Technical Service Bulletin Notification TSB #19-030

Battery Merge Solenoid Replacement

Bulletin Type:	TSB Technical Service Bulletin	Publication Date:	July 2019
Bulletin #:	19-030	Make(s):	Entegra
Job Code:	9803437	Model(s):	Anthem / Cornerstone
Flat Rate:	1 hour	Model Year(s):	2020

Fig.1

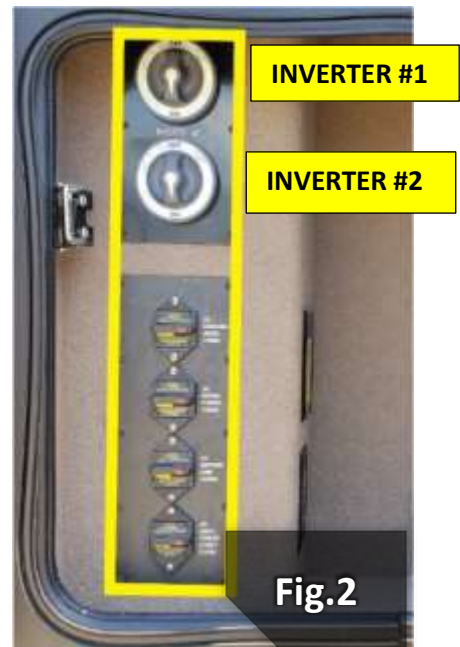
FIG 1:

- Locate the DCD Panel on the coach.
- DCD Panel is located the fourth bay back from the entrance door.

Fig.3

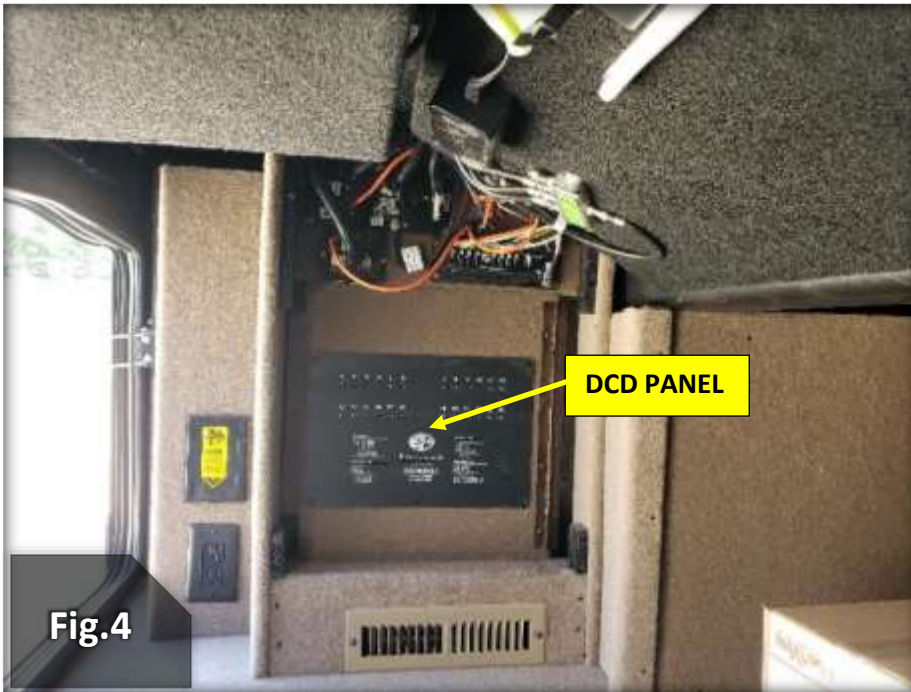
FIG 3:

- **POWER MUST BE DISCONNECTED BEFORE CONTINUING!**
- The DCD Panel is located behind a false carpeted panel.
- False panel is held in place with velcro, simply pull it away to remove it.

Fig.6

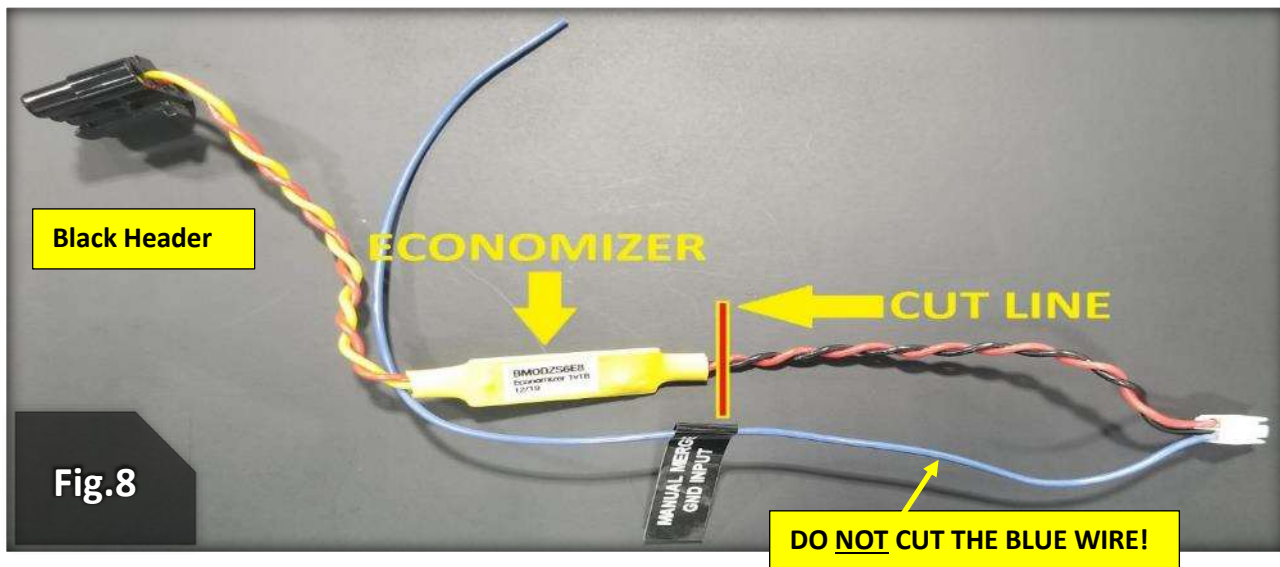
FIG 6:

- Locate the Gigavac Solenoid on the back side of the DCD Panel.
- Take note of cable and wire colors on the Gigavac Solenoid as they will need to be removed and re-installed on the new Solenoid in the same positions further on in the instructions.

Fig.9

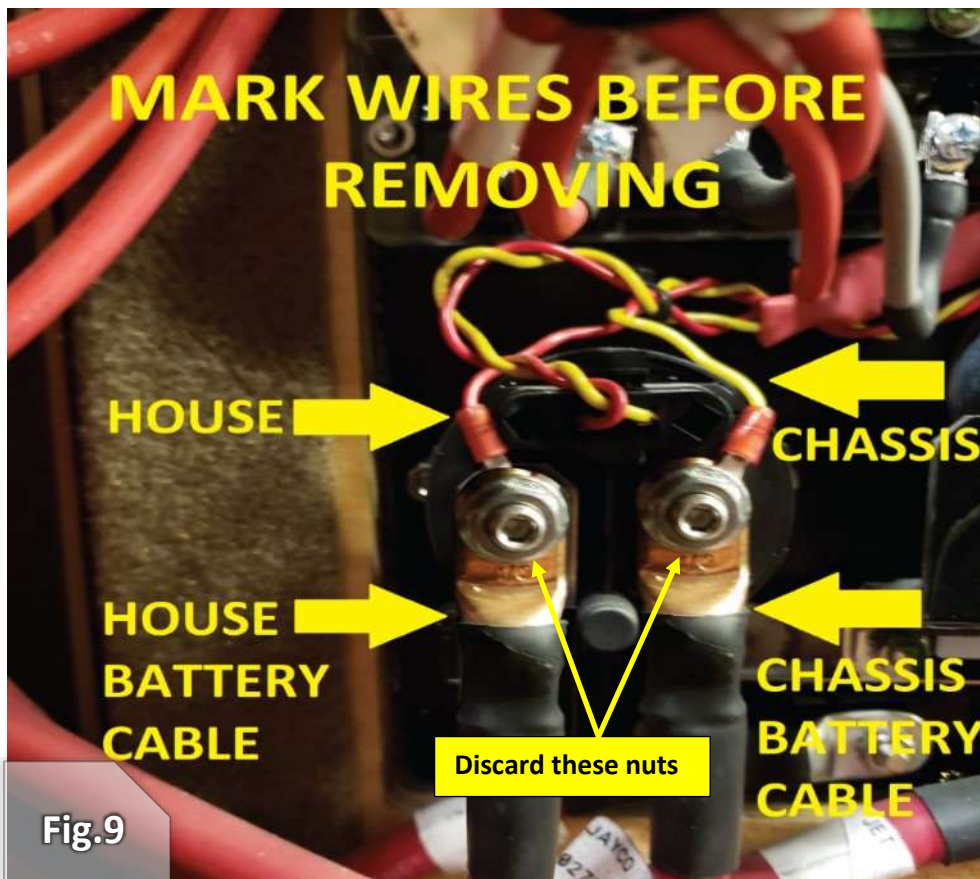
FIG 9:

- **ENSURE CIRCUIT BREAKERS ARE TURNED OFF BEFORE THIS STEP!**
- Mark and then remove Chassis and House sense wires (Red & Yellow wires) from the top of the Gigavac Solenoid.
- Mark and remove Chassis and House battery cables.
- Discard the nuts previously used to secure the House and Chassis terminals (**Fig 9**).

Fig.10

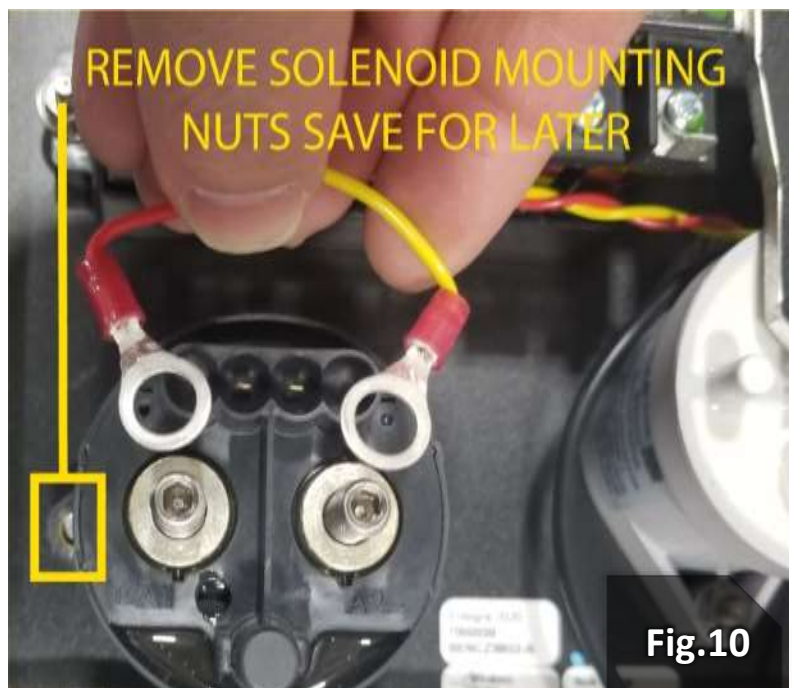
FIG 10:

- Remove the old Gigavac Solenoid from the panel.
RETURN THE OLD SOLENOID TO JAYCO. There are 2 nuts securing it to the panel. (Refer to rectangular box with yellow line pointing to one of the nuts)

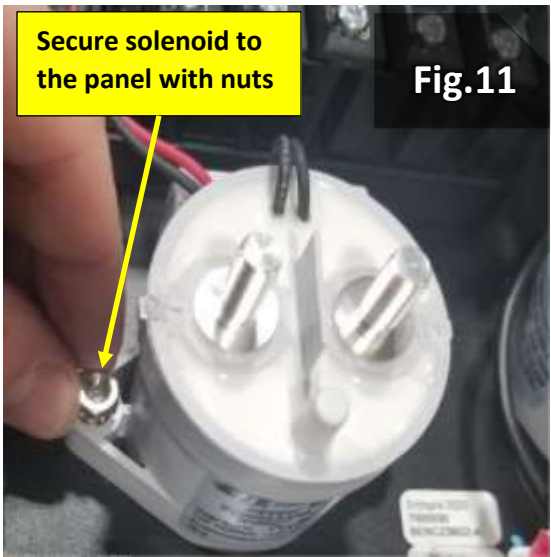
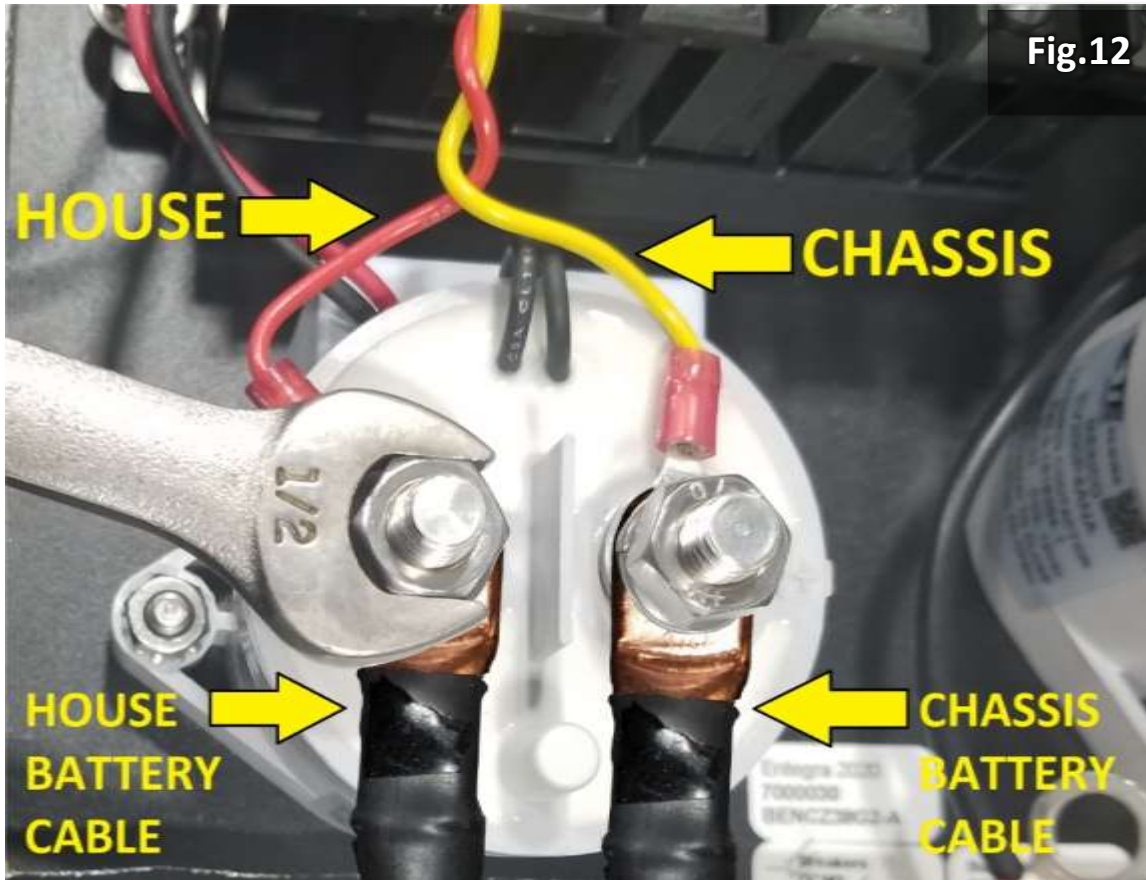
FIG 11:

- Install the new TE Solenoid from the kit, and secure with nuts that were previously used to secure the Gigavac Solenoid to the panel.
- TE Solenoid should be installed exactly as shown with the 2 pairs of wires positioned at the top.

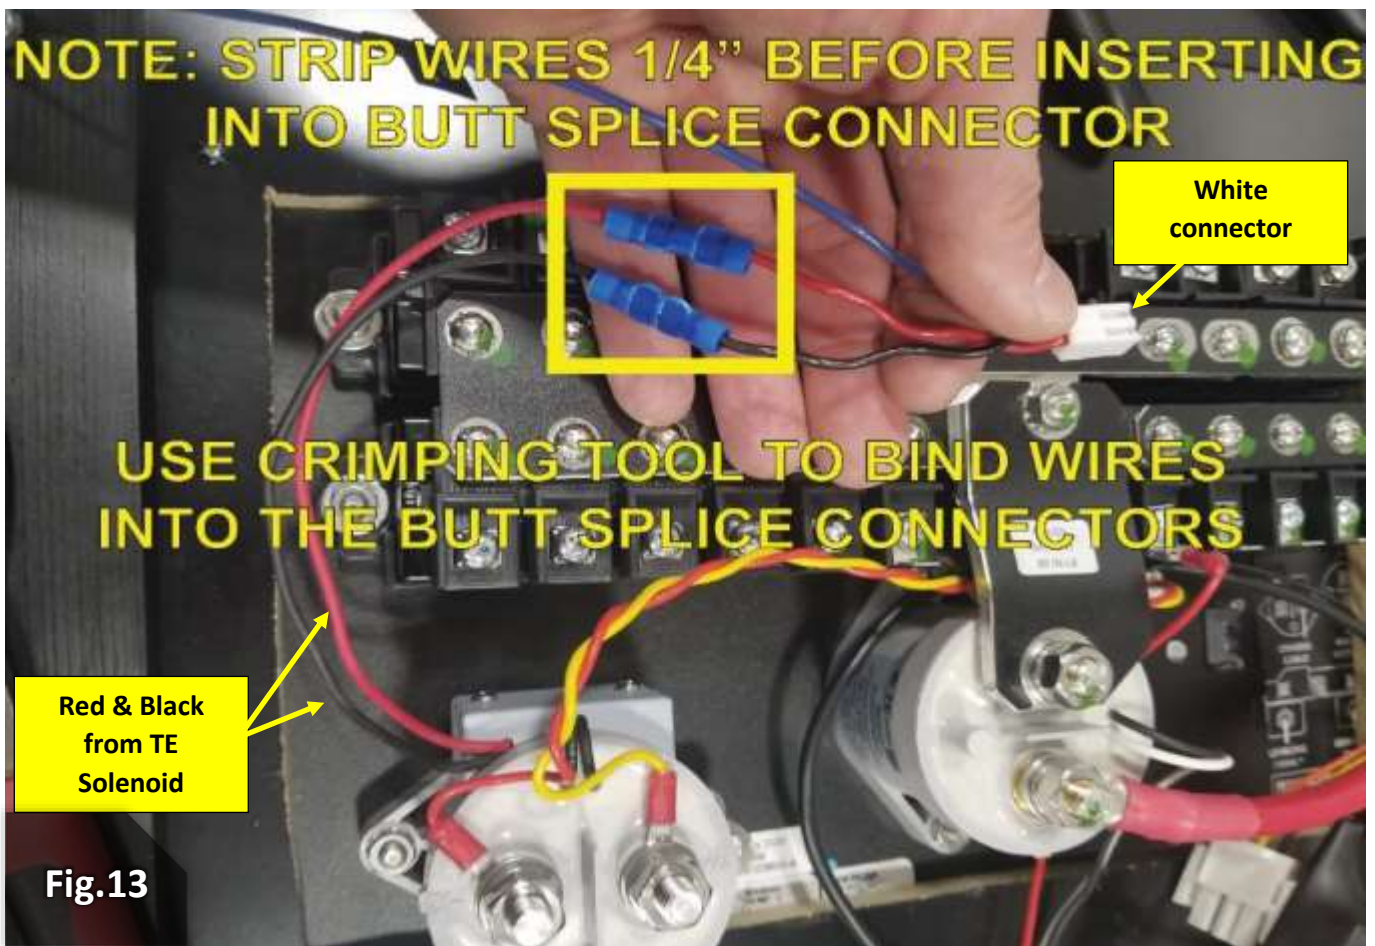
FIG 12:

- Install the House & Chassis battery cables first on the proper solenoid terminals.
- Then install the House (red wire) & Chassis sense (yellow wire) on the proper terminals.
- Use the new hardware provided with the new TE solenoid:
- Install the washers on the solenoid terminals.
- Install the nuts on the solenoid terminals.
- Tighten the nuts using the wrenches.
